**Public Service
Company of Colorado**
P.O. BOX 840
DENVER CO 80201-0840

January 9, 1992
Fort St. Vrain
Unit No. 1
P-92014

SUBJECT: **PSC RESPONSE TO NRC REQUEST FOR ADDITIONAL
INFORMATION ON THE FORT ST. VRAIN PROPOSED
DECOMMISSIONING PLAN**

PSC RESPONSE
TO NRC QUESTIONS NO. 11 & 38

DRAWING STATUS	
DESIGNED	2011E26
CHECKED	
APPROVED	
DATE	2011E26
BY	
FOR

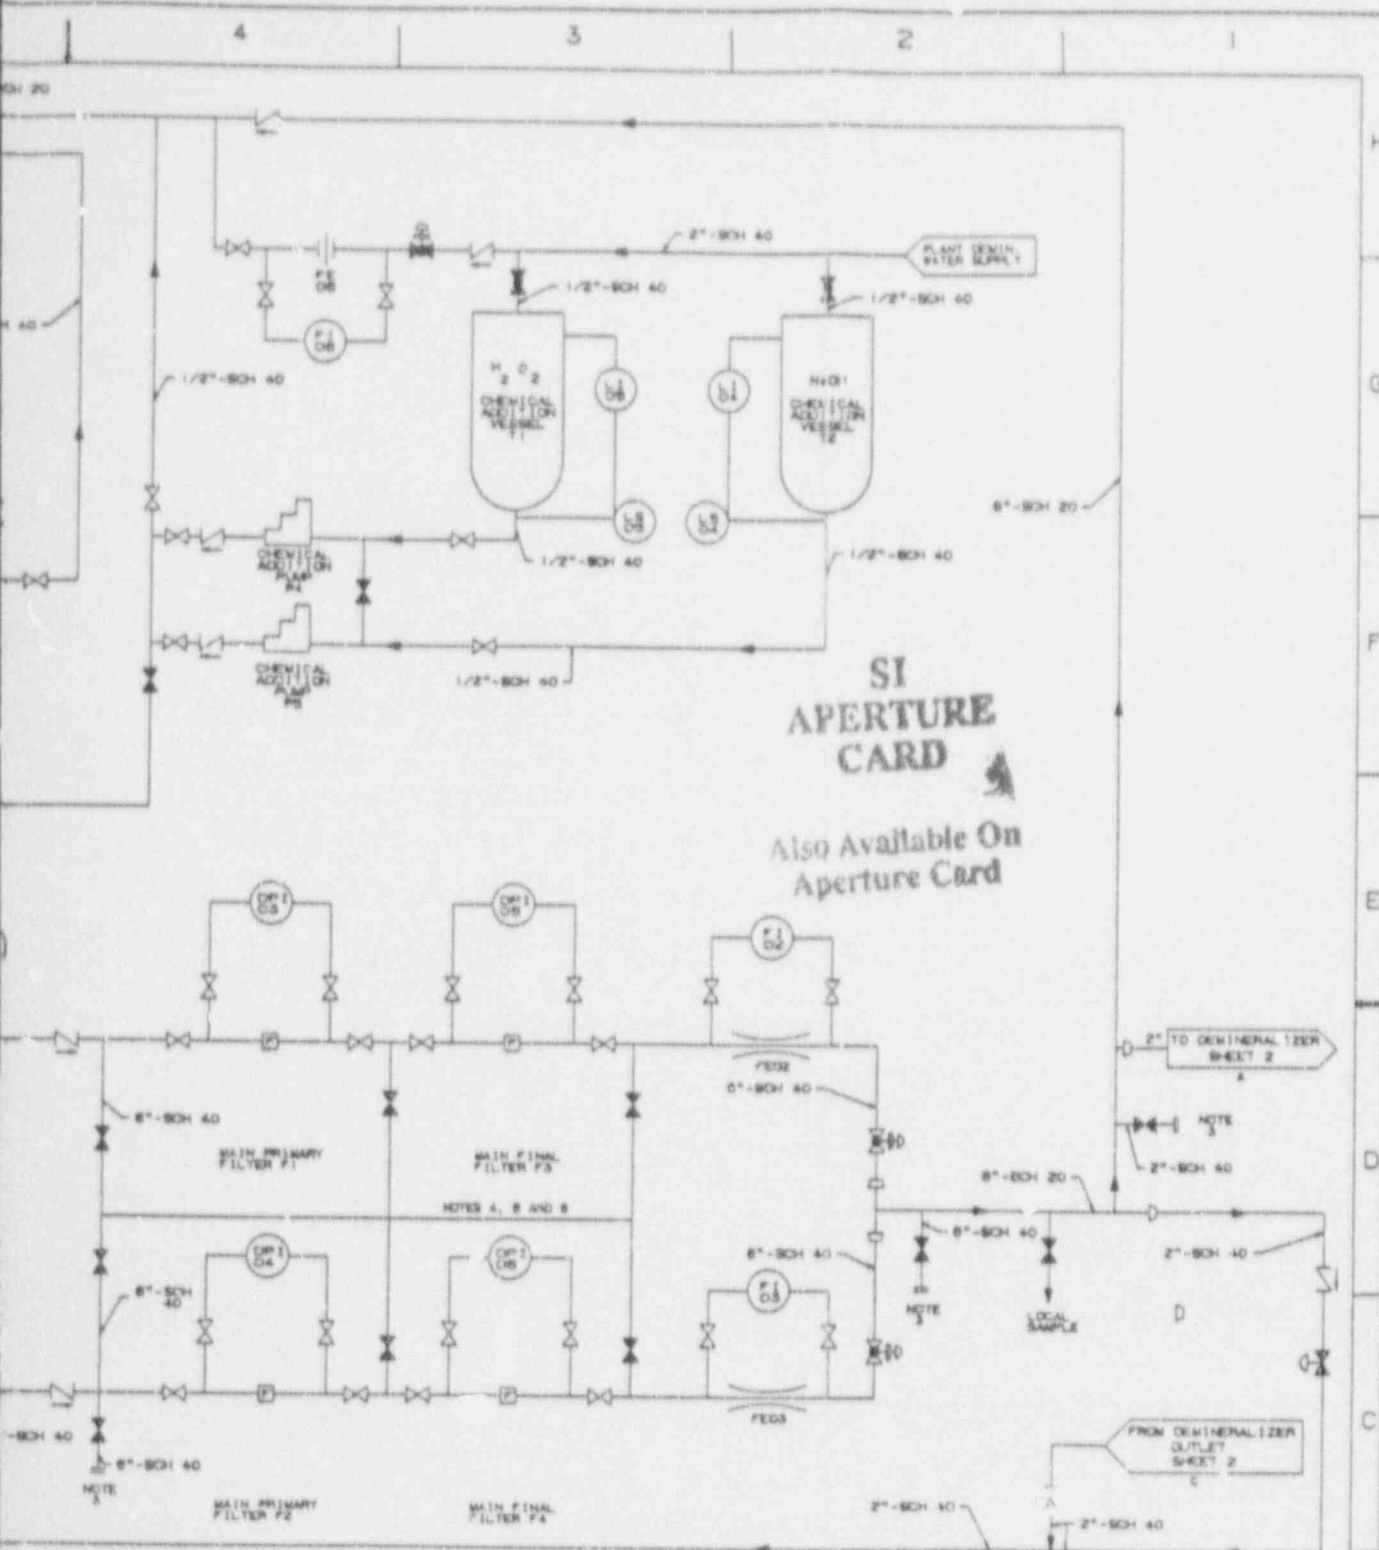
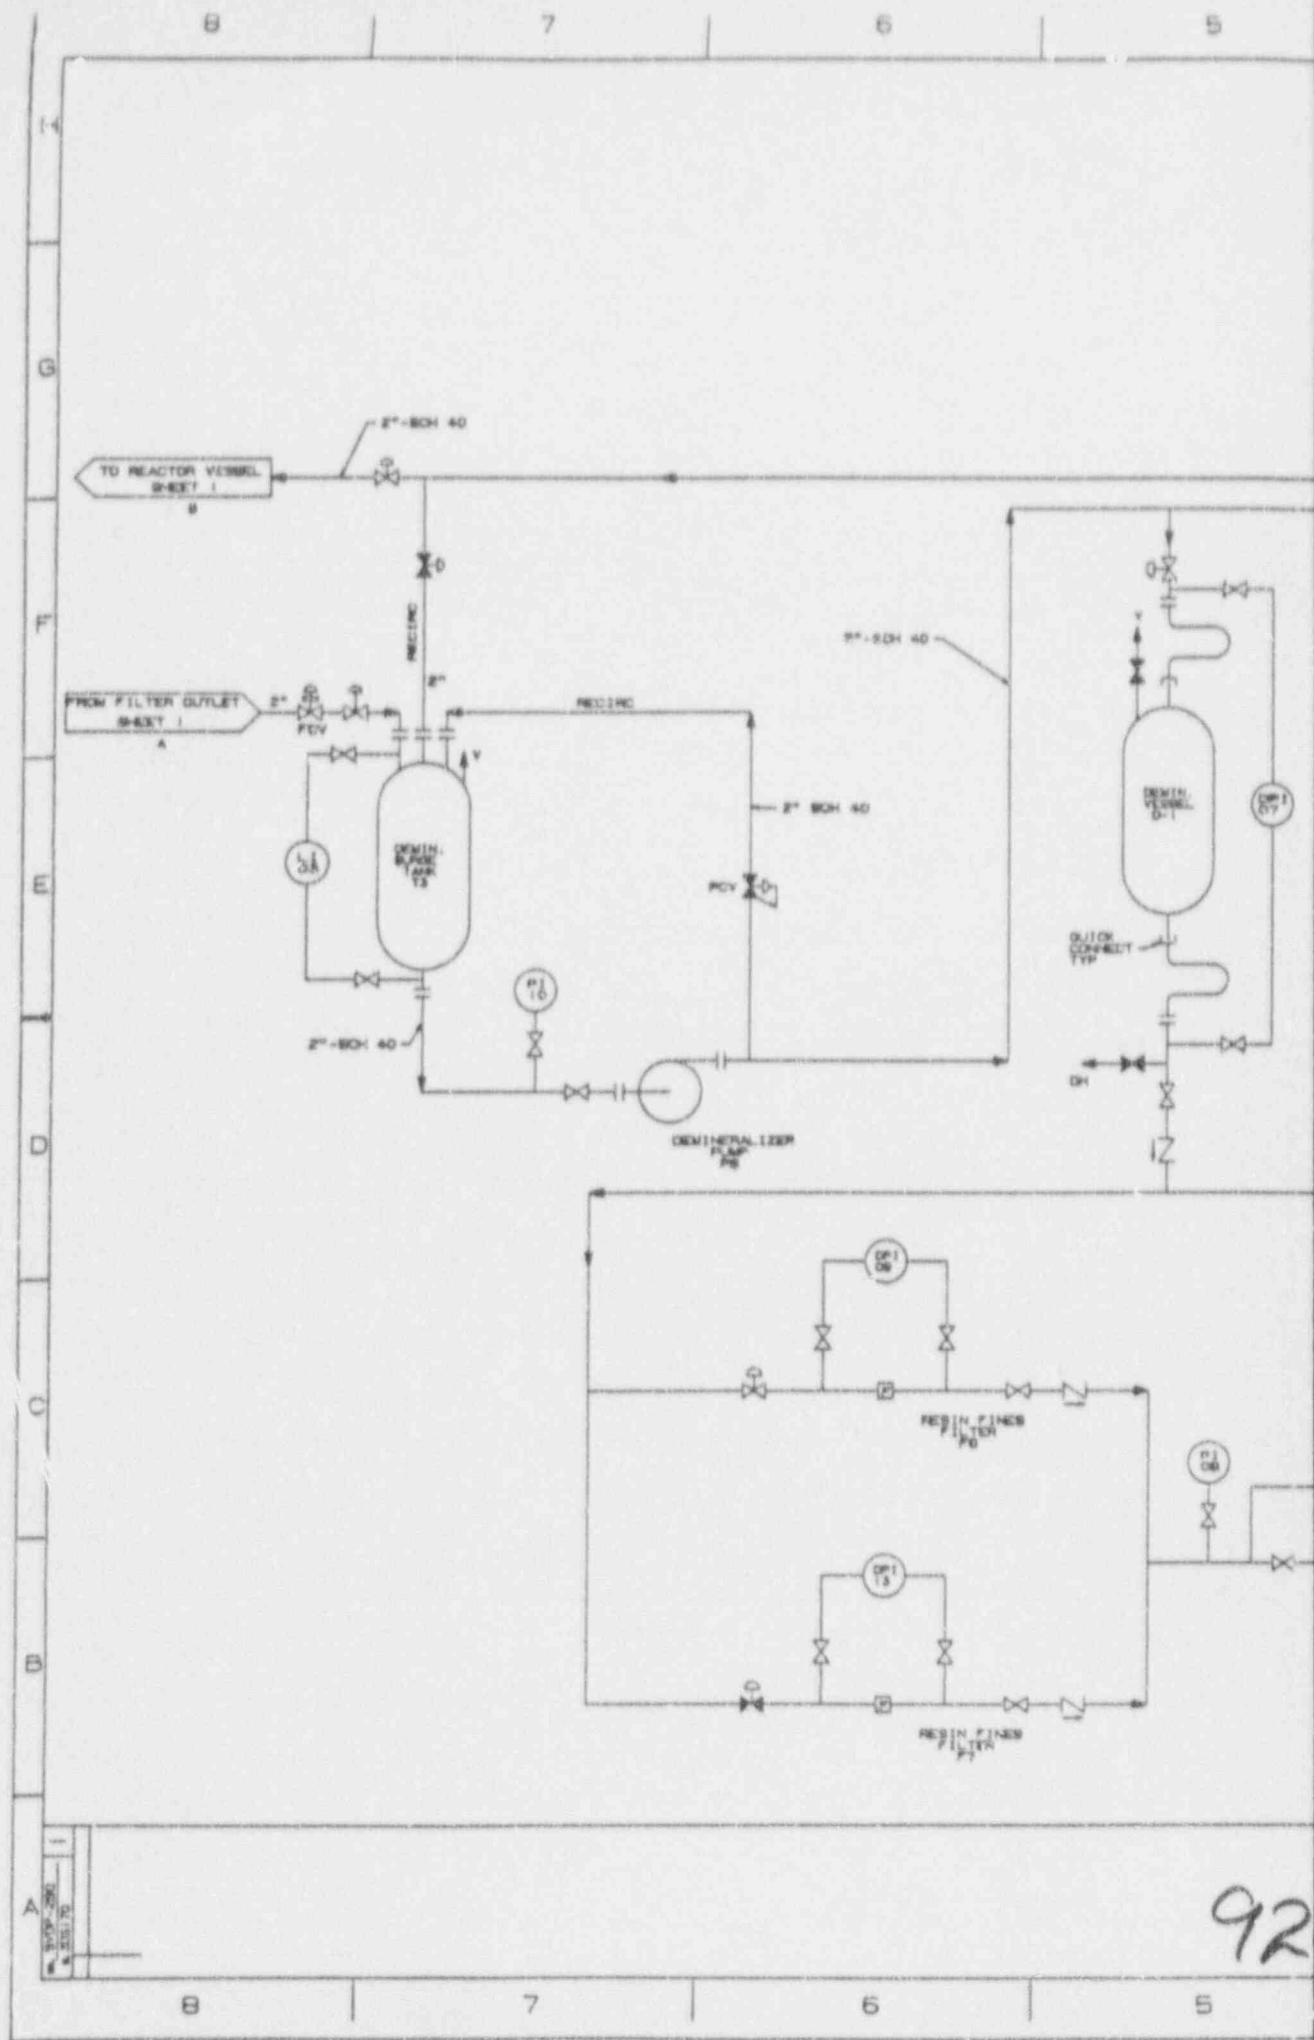
NRC Question 11 (Section 2.3.3.6.2: Water Cleanup and Clarification System)

"Provide analysis of radiological consequences of system operation. Further, provide a safety analysis for potential accident scenarios with regard to occupational and public exposure. Include analysis of radioactive material (including tritium) that is released to this system."

The PCRV Shield Water System is shown in Figure 11-1 (Westinghouse Flow Diagram 2011E26). The system will consist of two parallel trains of equipment, each sized for 500 gpm (or 50%) of the total flow. This total design flow rate (1000 gpm) will provide a turnover rate of approximately five PCRV volumes per day. Based on discussions with personnel involved in the TMI cleanup, this rate is considered

All three paths will be capable of discharge to: (1) the existing radioactive liquid waste tanks; (2) the Reactor Building sump discharge line; or (3) a PCRV Shield Water System waste holdup tank (see sheet 2 of Figure 11-1).

Figure 38-1 Core Graphite Components - Elevation View

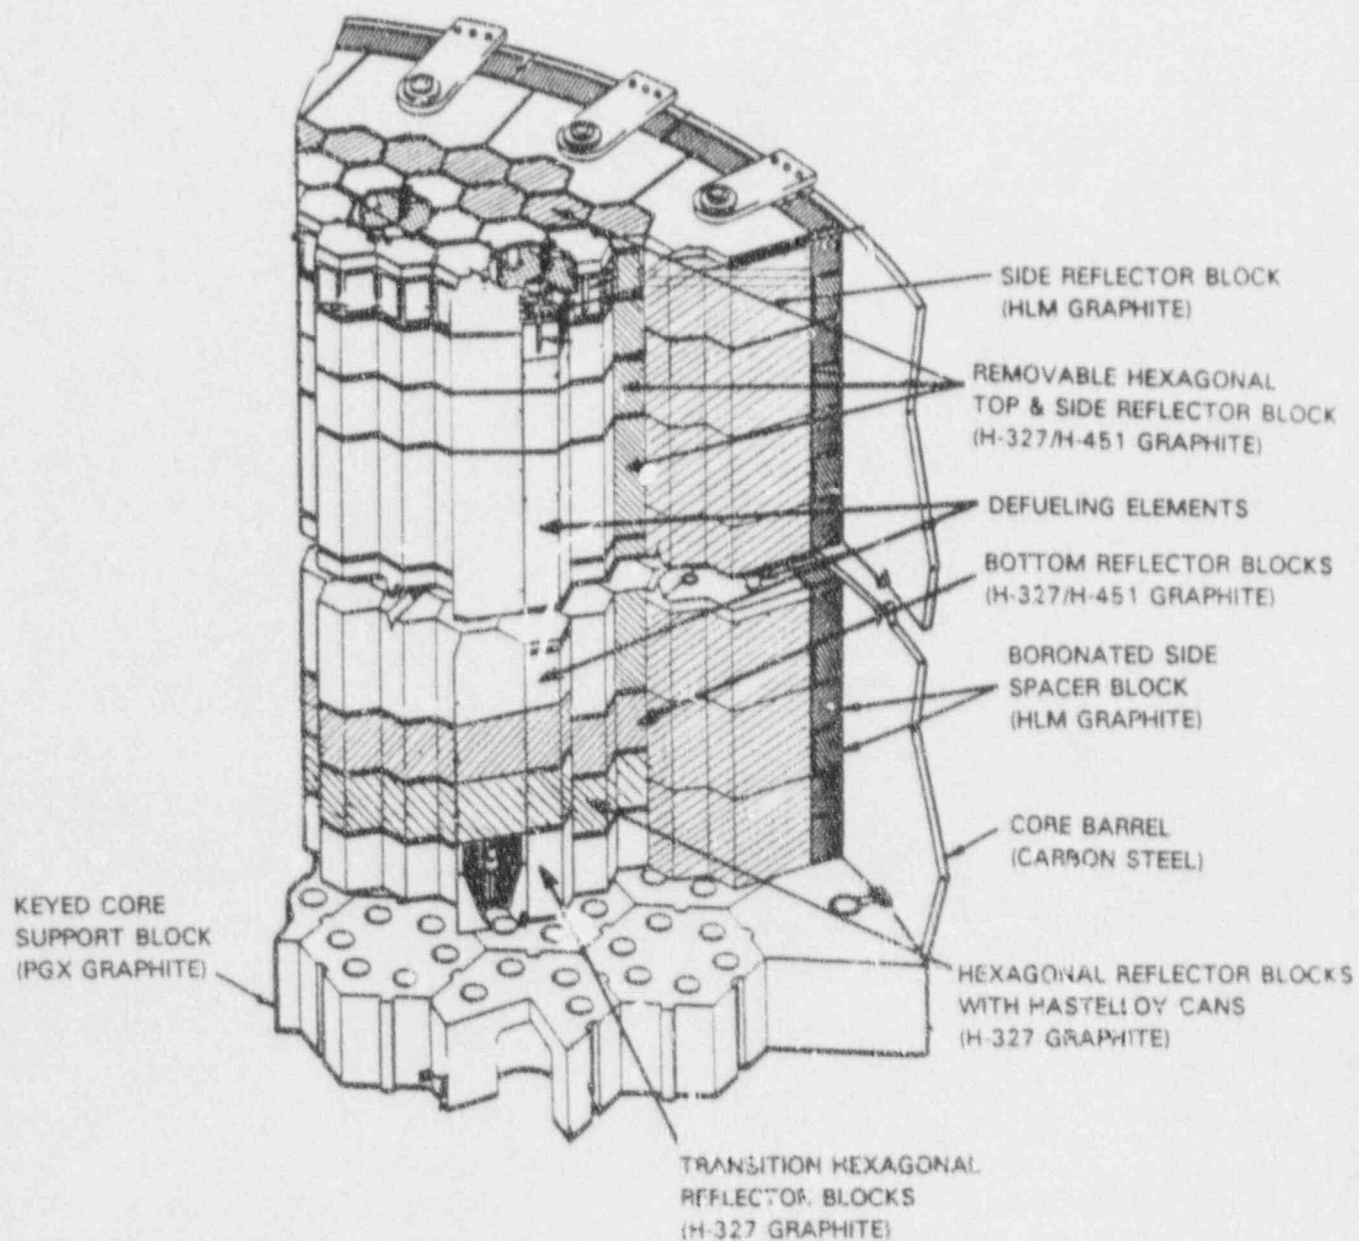
- A. *PSC estimates that about 500 curies of tritium would be released to the PCRV shield water from the 100,000 curies of tritium in the graphite (one-half of one percent). PSC's April 26th response and July 1st revision to the Decommissioning Plan states that the estimated tritium release from graphite blocks to PCRV shield water is "based on data." The source of this data must be provided and its accuracy and applicability justified. Include in these evaluations the structure of graphite blocks, e.g. unclad and material composition.*

Figures 38-1 and 38-2 provide plan and elevation views of the core area that identify the key components and type of graphite used for each. From the standpoint of tritium generation, the graphite in Fort St. Vrain is primarily of two types. The primary graphite of interest is the HLM graphite, which was used for the large side reflector blocks and the side spacer blocks. HLM graphite is less pure than the graphite used in fuel elements, with a maximum specification for lithium of 2 ppm.
